S4.55 MODIFICATION

S4.55 MODIFICATIONS	
Change ID	Name
Ch-01	Courtyard wall moved into courtyard
Ch-02	Alfresco deck reshaped
Ch-03	New window to first floor bathroom (W29)
Ch-04	Western wall on first floor moved forward by 650mm & balcony removed
Ch-05	New window to ground floor Dining (W20)
Ch-06	W04 - Kitchen window size change
Ch-07	Skylights relocated from stairwell to hallway
Ch-08	Eastern balcony screen reduced in length
Ch-09	Cellar footprint revised to include sauna

S4.55 MODIFICATION		
project	1130 PITTWATER RD	
	COLLAROY	
drawing	COVER SHEET	
drawn	SM / PC	checked MA
date	09.02.24	scale @ A3
project no	2_23_10	drawing no D0000
		issue F

SUBMISSION
S4.55 MODIFICATION
project 1130 PITTWATER RD
drawing **COLLAROY**
SITE PLAN
drawn SM / PC checked MA
date 09.02.24 scale 1:200 @ A3
project no 2_23_10 drawing no D0003 issue F

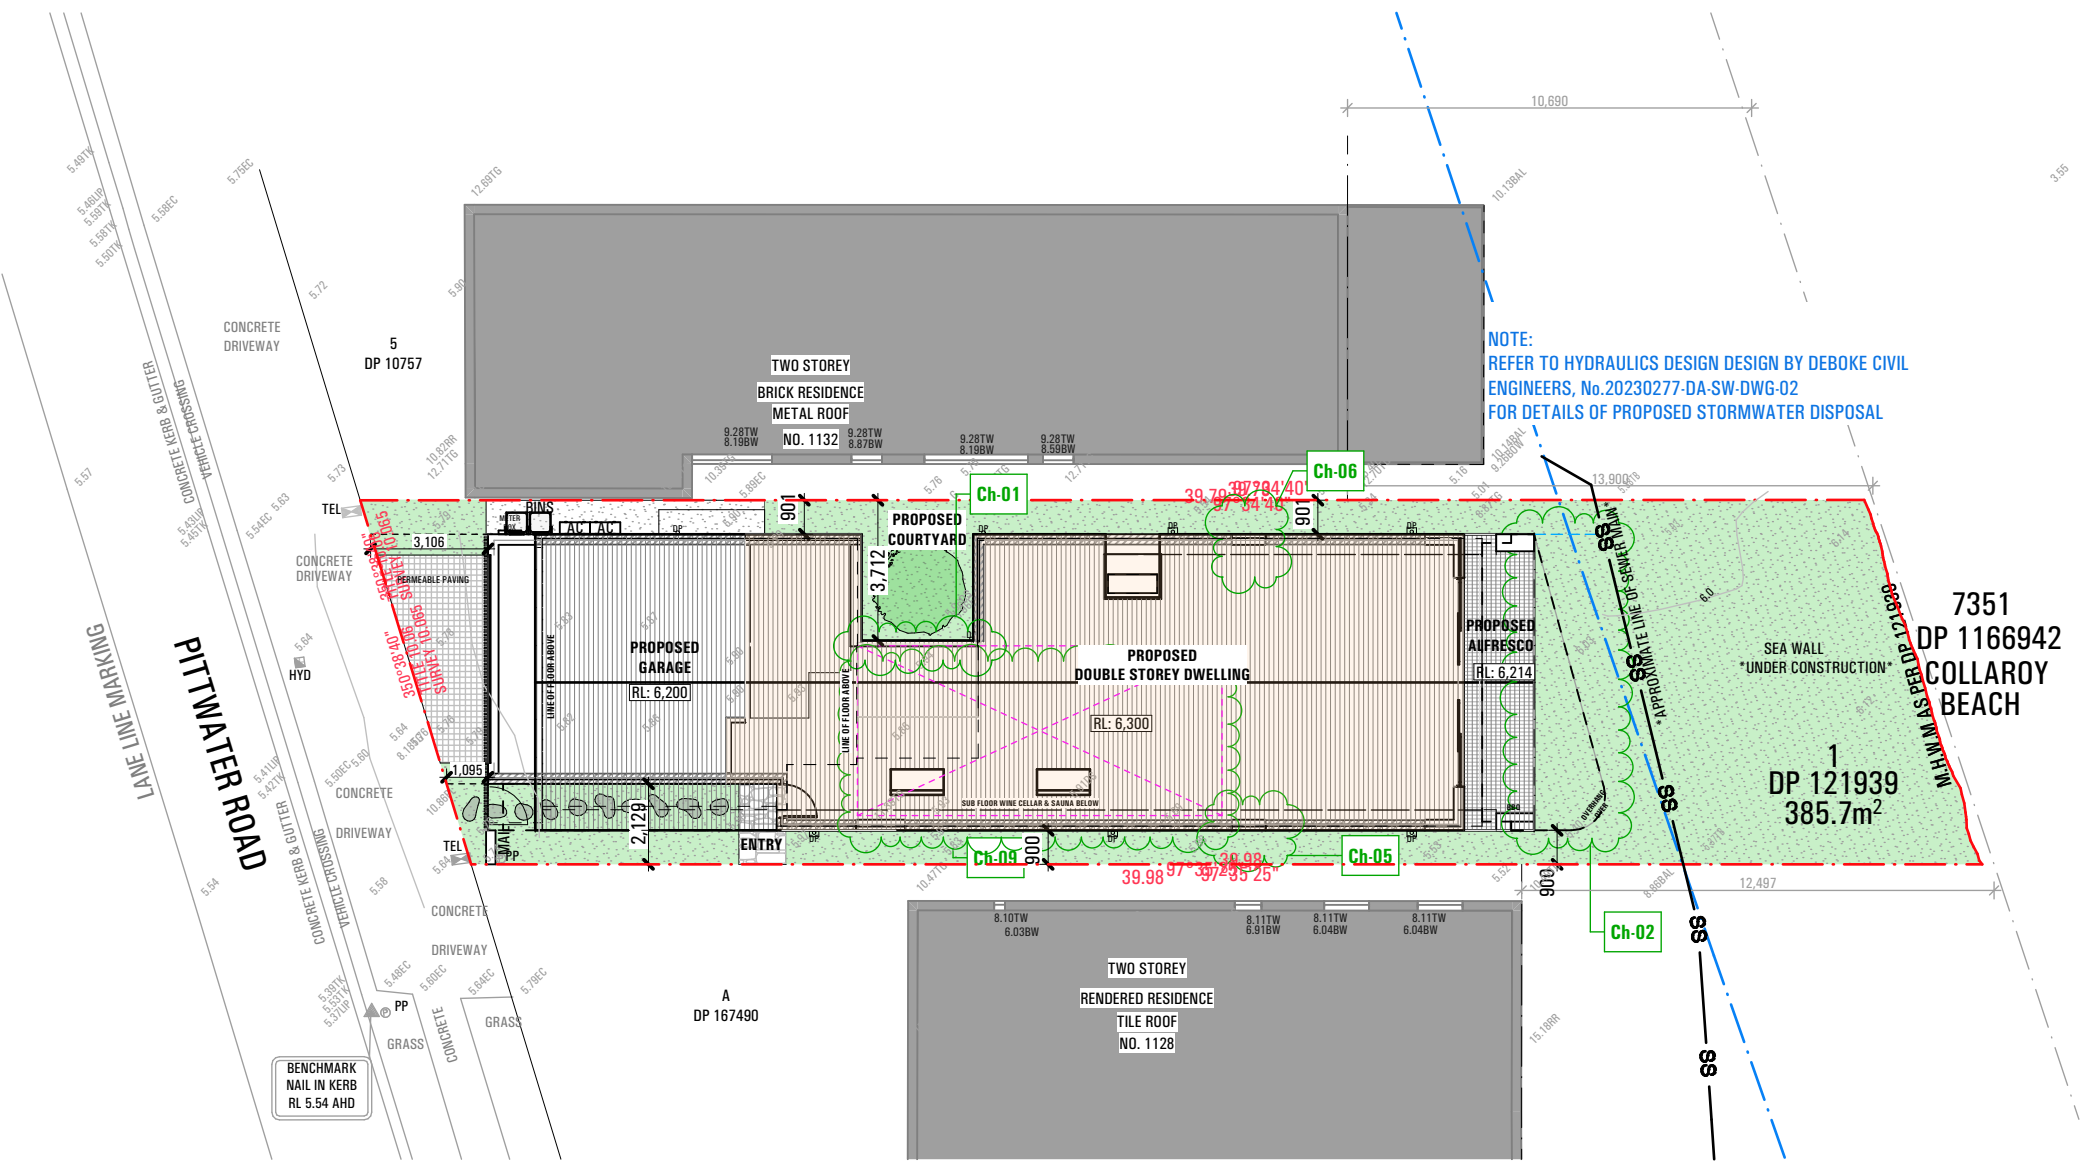
S4.55 MODIFICATIONS	
Change ID	Name
Ch-01	Courtyard wall moved into courtyard
Ch-02	Alfresco deck reshaped
Ch-03	New window to first floor bathroom (W29)
Ch-04	Western wall on first floor moved forward by 650mm & balcony removed
Ch-05	New window to ground floor Dining (W20)
Ch-06	W04 - Kitchen window size change
Ch-07	Skylights relocated from stairwell to hallway
Ch-08	Eastern balcony screen reduced in length
Ch-09	Cellar footprint revised to include sauna

S4.55 MODIFICATION		
project	1130 PITTWATER RD	
	COLLAROY	
drawing		
drawn	SM / PC	checked MA
date	09.02.24	scale @ A3
project no	2_23_10	drawing no D2100
		issue F

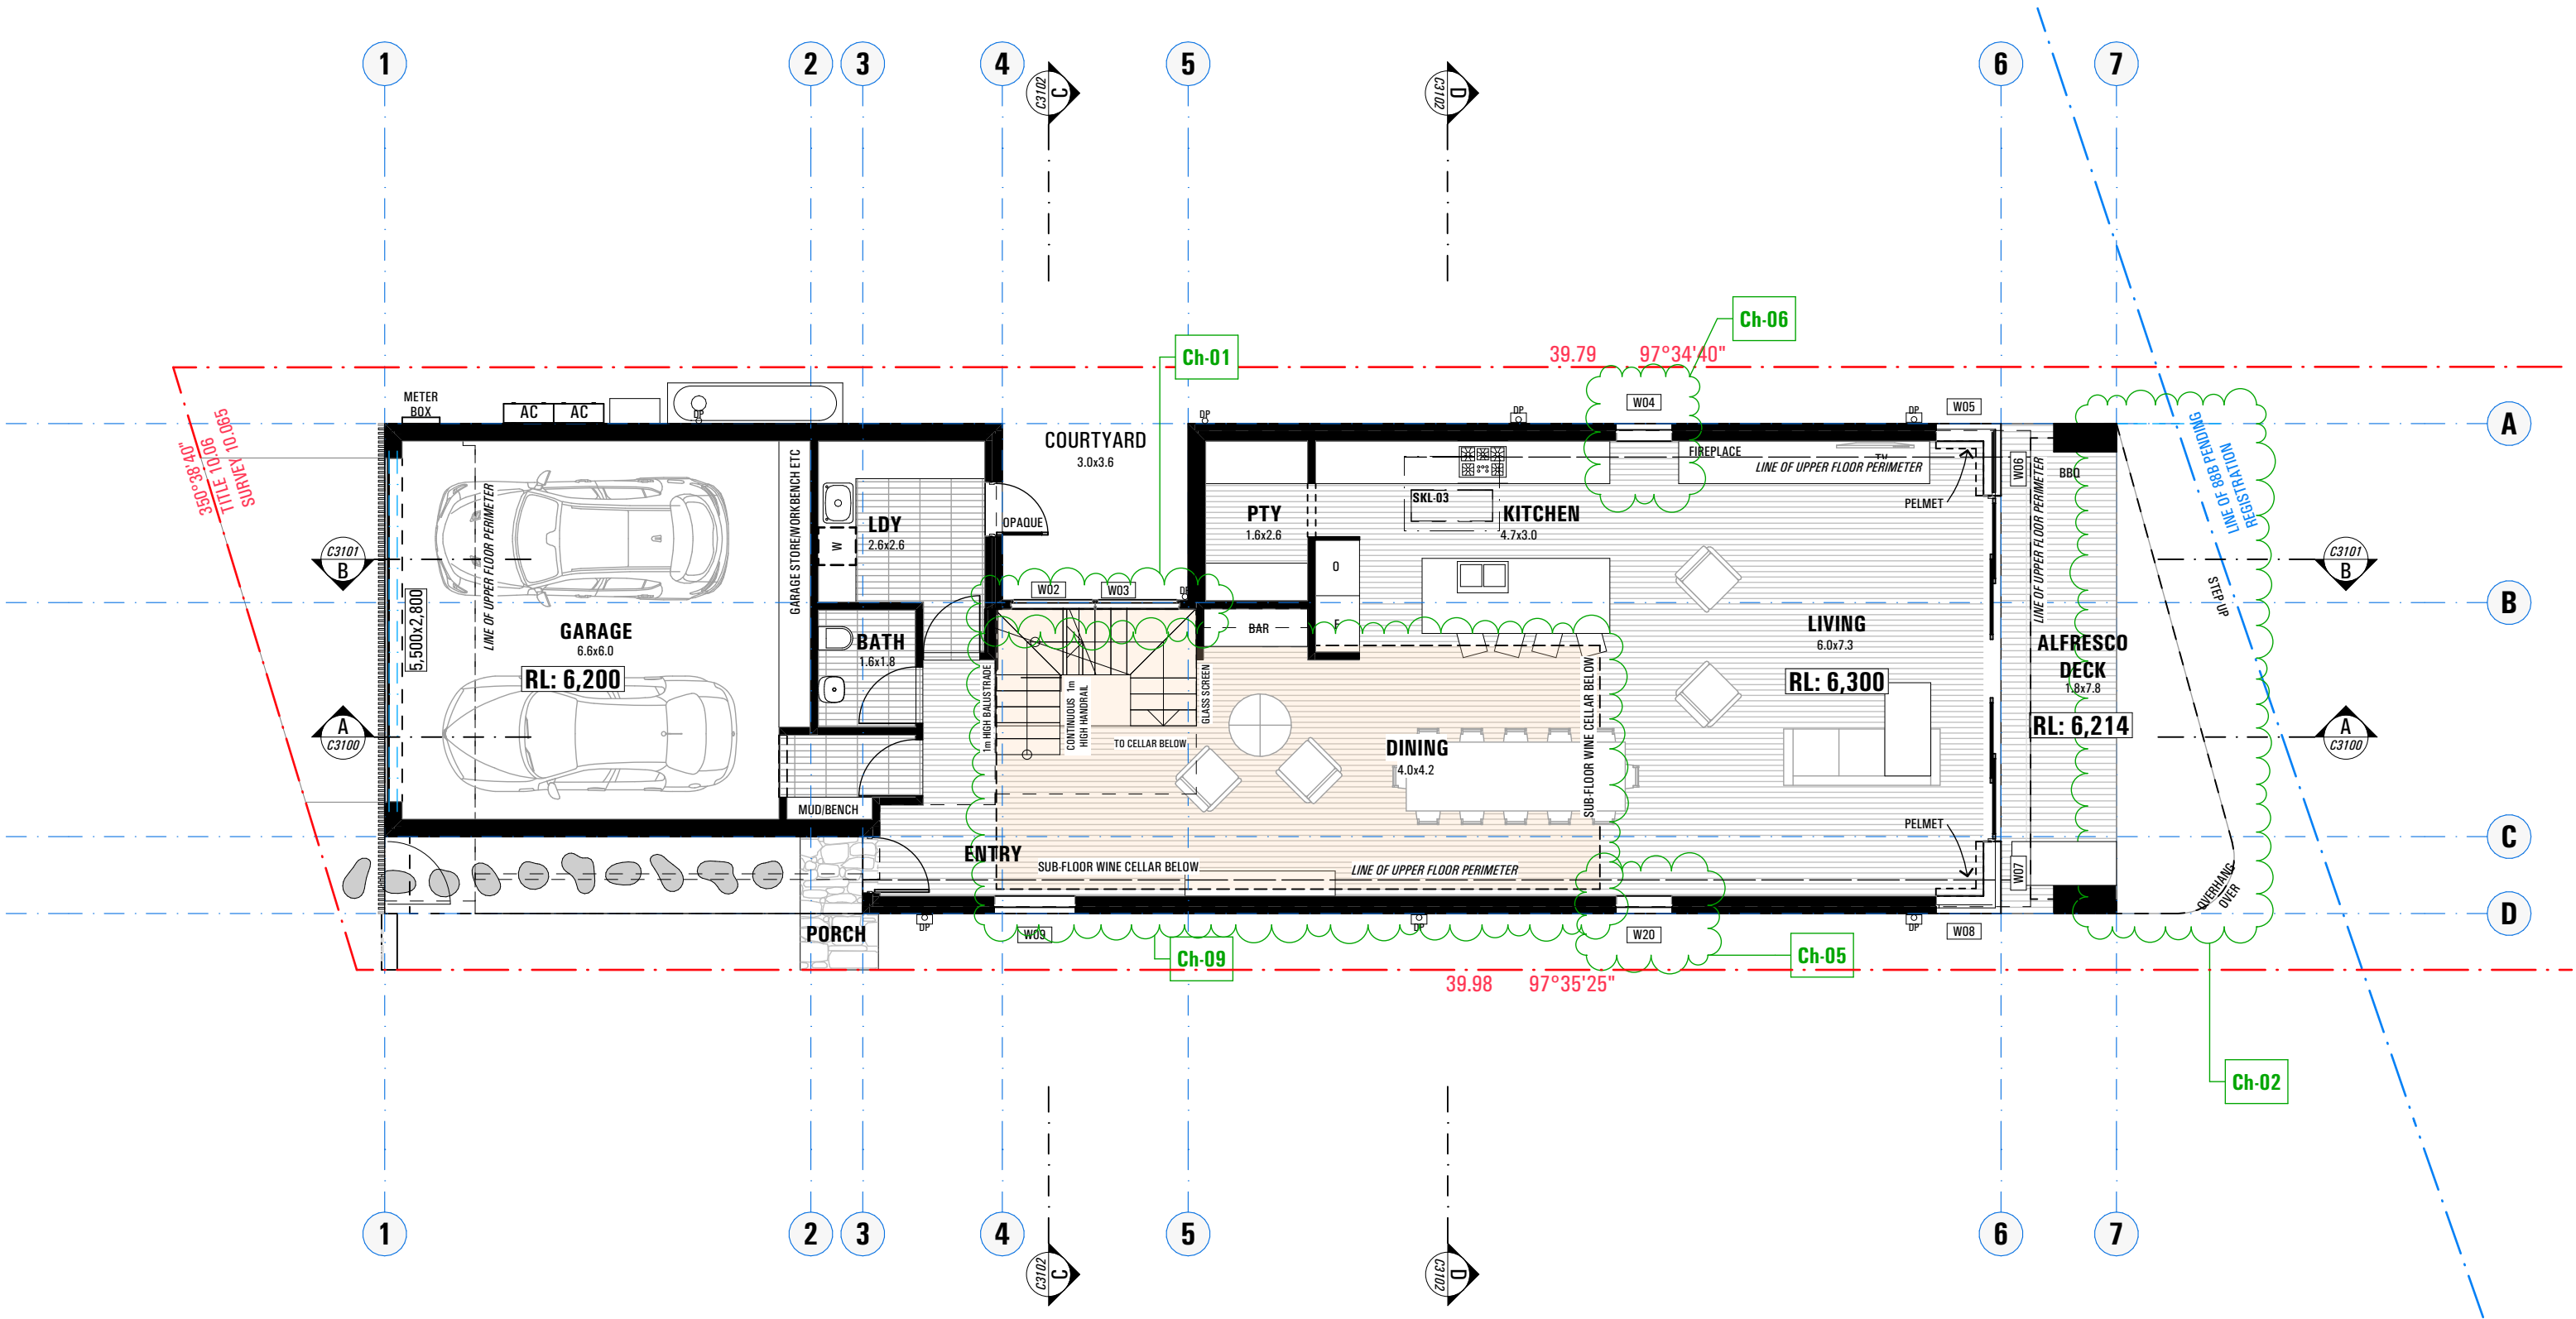
Change ID	Name
Ch-01	Courtyard wall moved into courtyard
Ch-02	Alfresco deck reshaped
Ch-03	New window to first floor bathroom (W29)
Ch-04	Western wall on first floor moved forward by 650mm & balcony removed
Ch-05	New window to ground floor Dining (W20)
Ch-06	W04 - Kitchen window size change
Ch-07	Skylights relocated from stairwell to hallway
Ch-08	Eastern balcony screen reduced in length
Ch-09	Cellar footprint revised to include sauna

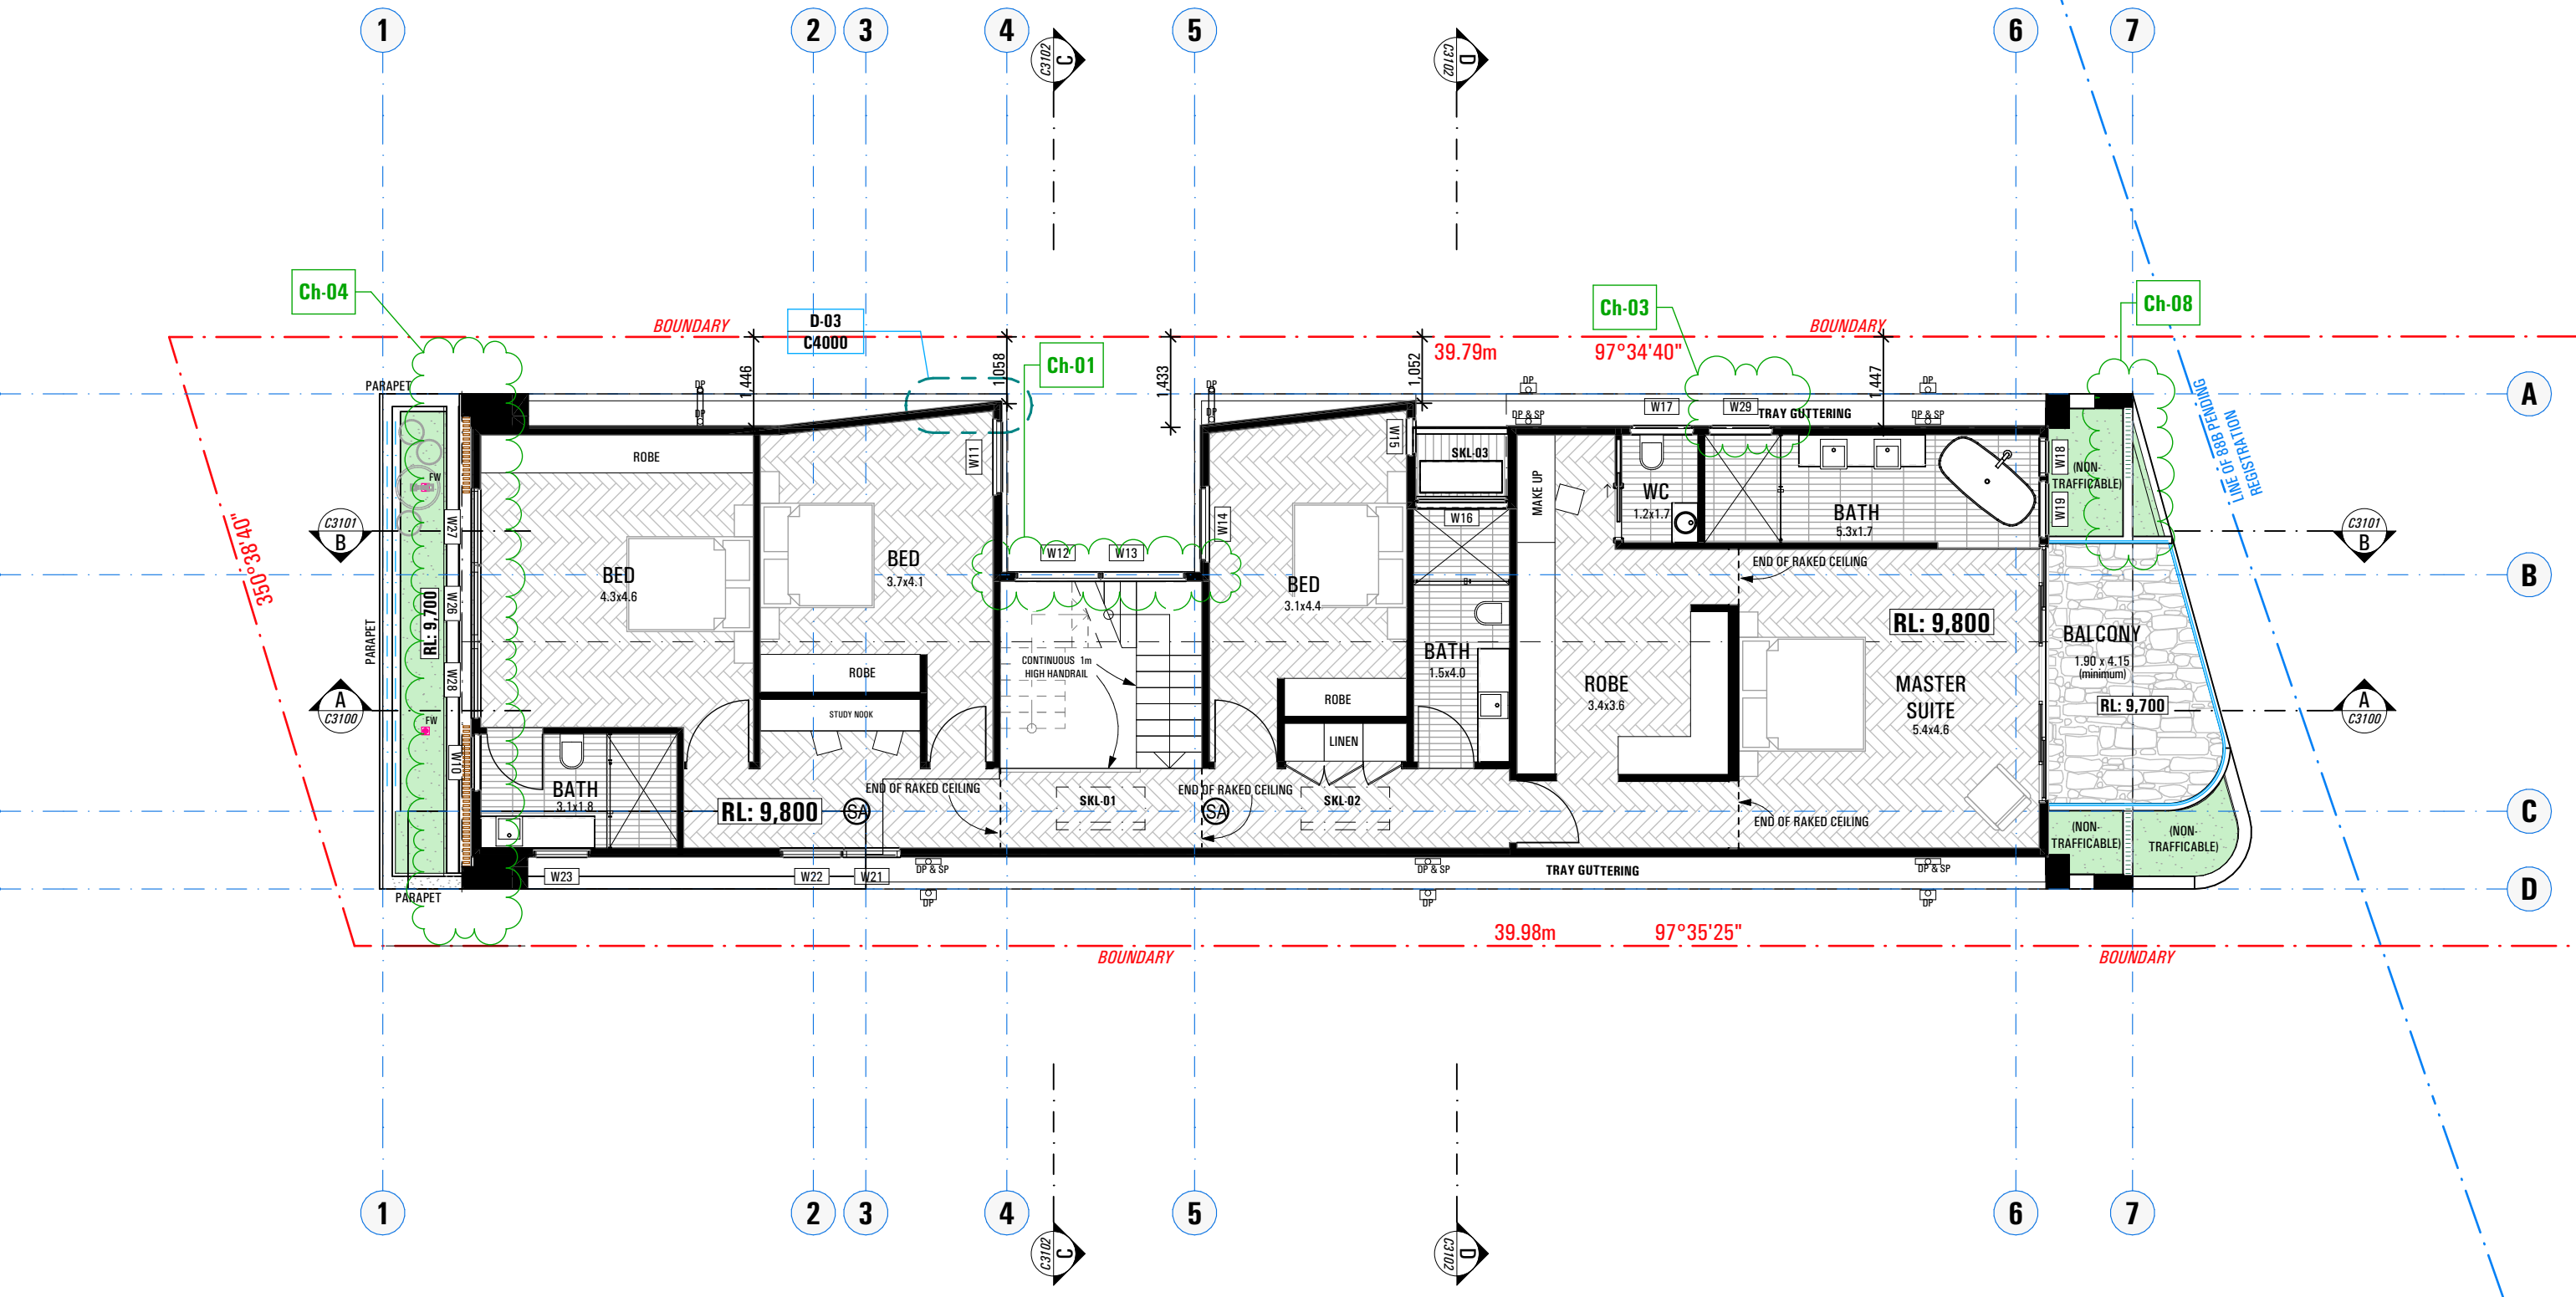
S4.55 MODIFICATIONS	
Change ID	Name
Ch-01	Courtyard wall moved into courtyard
Ch-02	Alfresco deck reshaped
Ch-03	New window to first floor bathroom (W29)
Ch-04	Western wall on first floor moved forward by 650mm & balcony removed
Ch-05	New window to ground floor Dining (W20)
Ch-06	W04 - Kitchen window size change
Ch-07	Skylights relocated from stairwell to hallway
Ch-08	Eastern balcony screen reduced in length
Ch-09	Cellar footprint revised to include sauna
